Letter No. 99008-05-002

SUBJECT: Supplemental Information Submittal, Mixed Oxide Fresh Fuel Package (MFFP) Application, Docket No. 71-9295, TAC No. L23747

Mixed Oxide Fresh Fuel Package

Safety Analysis Report

Figure 1.2-12 – BPR Assembly

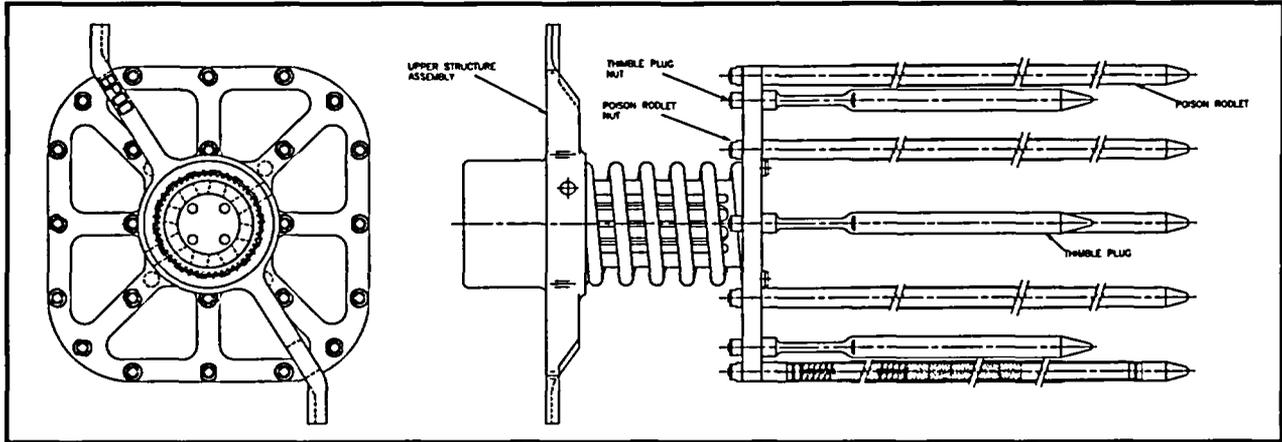
3. Provide the physical and nuclear parameters for the Burnable Poison Rod Assembly.

Response: Section 1.2.3, *Contents of Packaging*, has been revised to include the physical and nuclear descriptions for the Burnable Poison Rod Assemblies (BPRAs). The revised section is part of Revision 2 of the SAR.

FIGURE 2.12.8-1 – Impact Conditions at the Top Plate – Closure Lid Interface

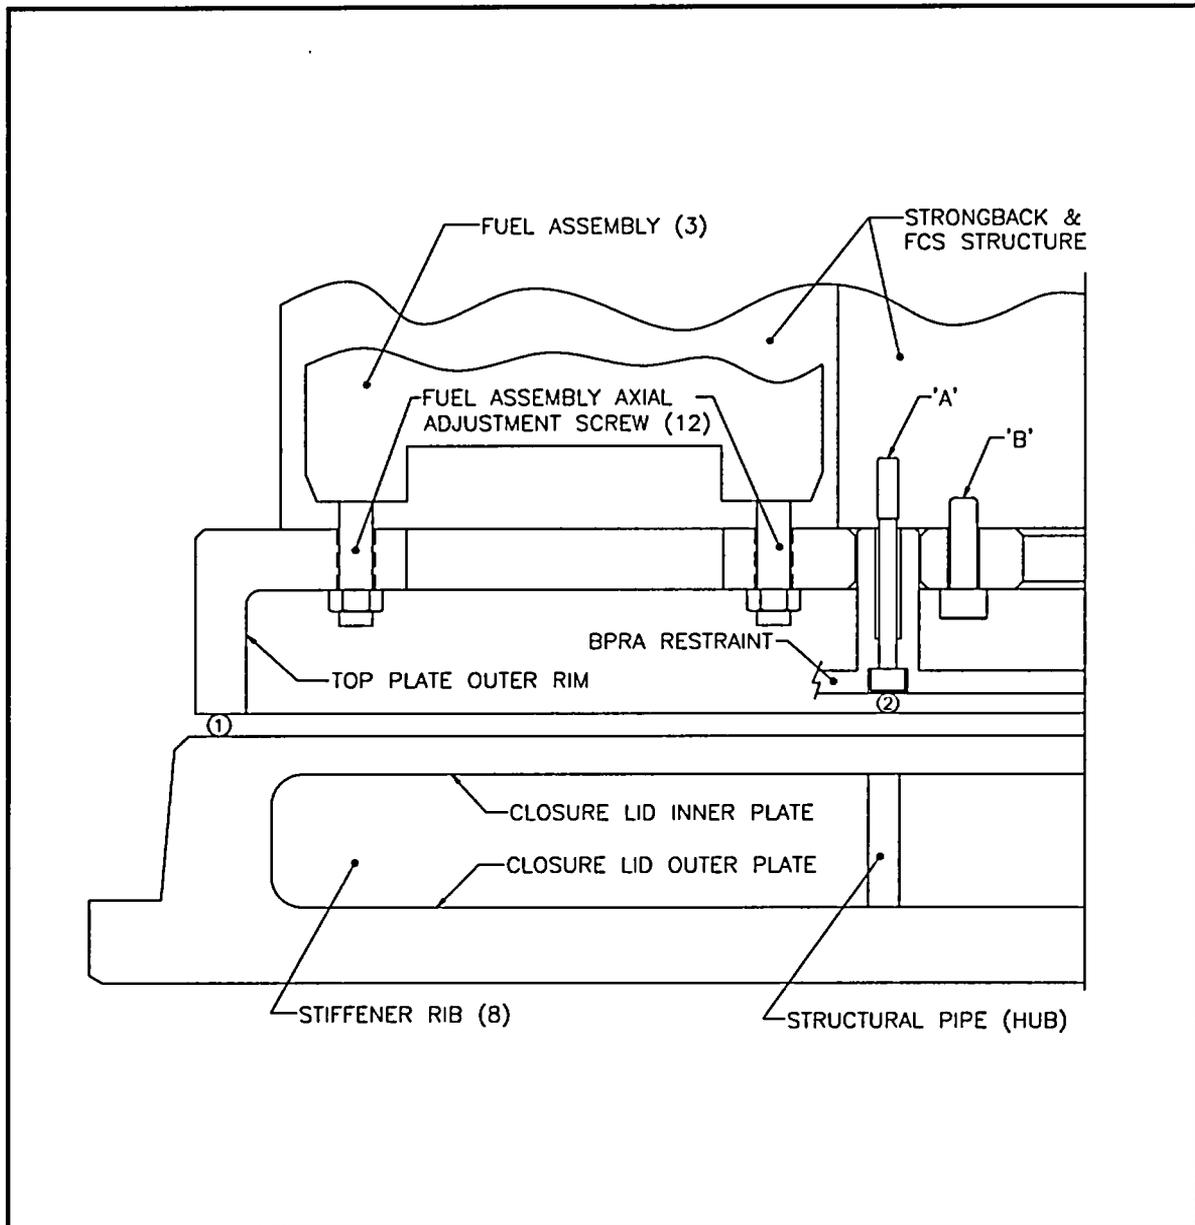
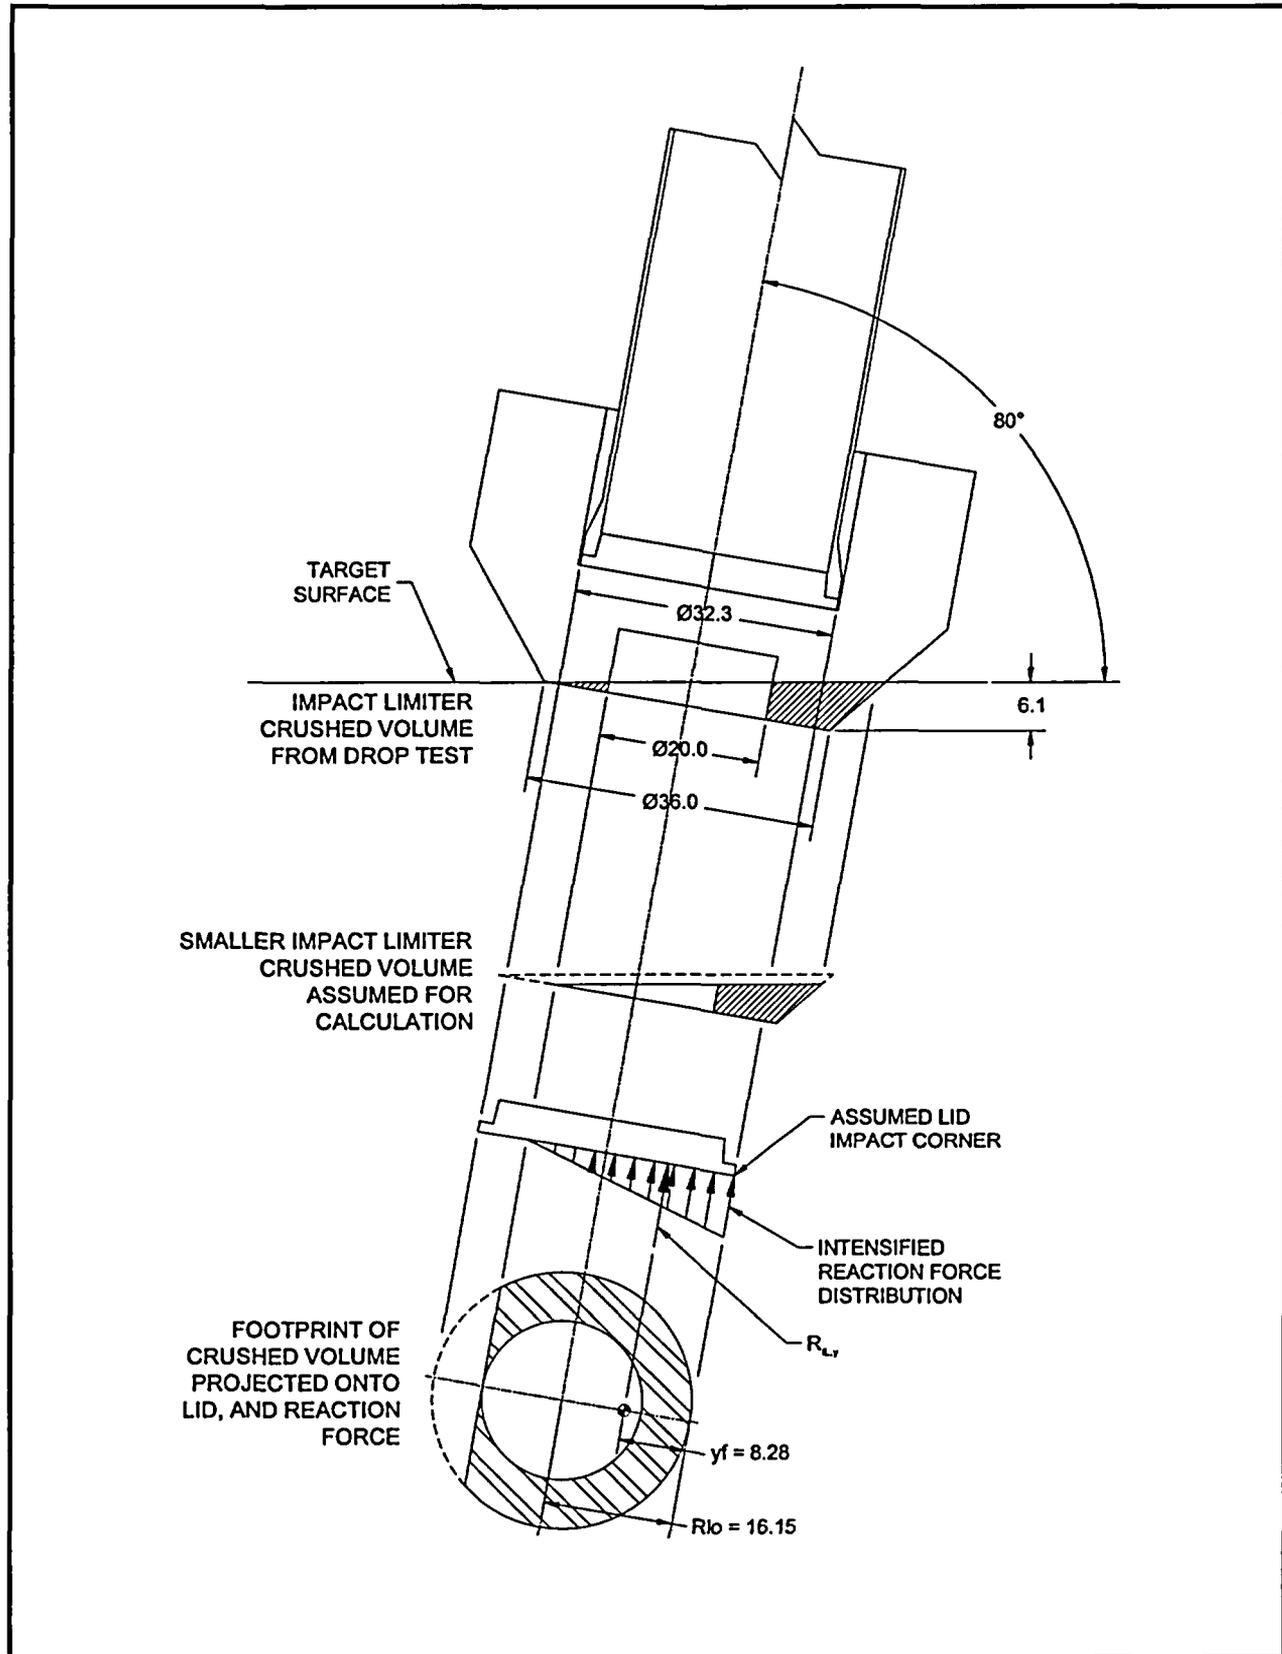
2. Explain the packaging responses as the result of additional weight from the FCS added to the design after the full-scale drop tests.

Response: Appendix 2.12.8, *Effect of Bounding Weight on Package Structural Responses*, has been added to Revision 2 of the SAR to address the packaging responses as a result of the additional weight of the FCS.
